Addendum 54: Regulation No. 55

Revision 1 - Amendment 1

Supplement 1 to the 01 series of amendments: Date of entry into force: 17 March 2010

**UNIFORM PROVISIONS CONCERNING THE APPROVAL OF MECHANICAL
COUPLING COMPONENTS OF COMBINATIONS OF VEHICLES**

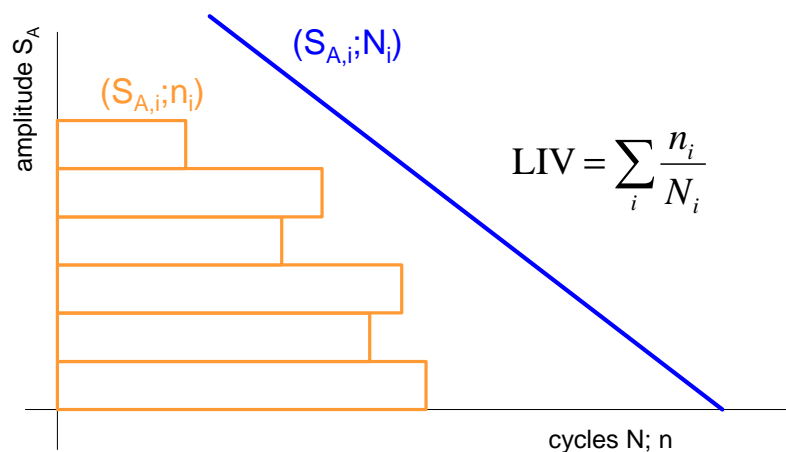
3.10.1. Introduction

The endurance test described below consists of a multi-axial test with 3 load directions, with simultaneously introduced forces, defined maximum amplitudes and fatigue equivalences (load intensity values, according to the definition given below).
